SUNDRY NOTICES AND REPORTS ON WELLS
Do not use this form for proposals to drill or to re-enter an abandoned well. Use Form 3160-3 (APD) for such proposals.

8. Well Name and No.
FEDERAL BN #2

9. API Well No.
30-015-32721

Federal BN #2

PROPOSED

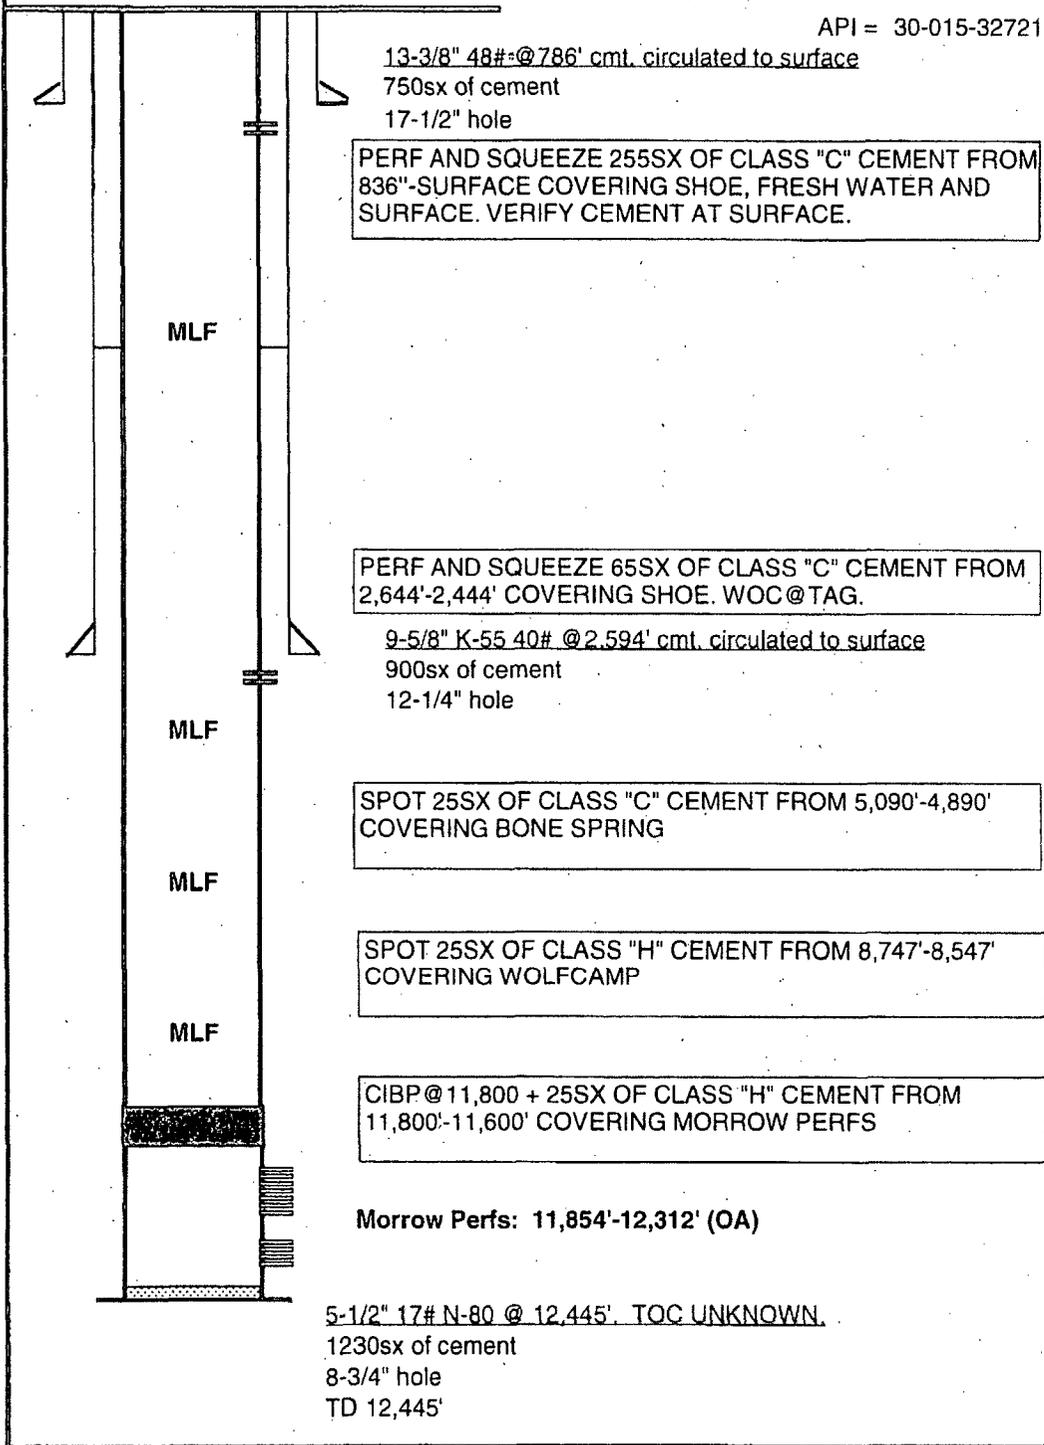
*Add plugs; from 10736-10536
from 9430-9240*
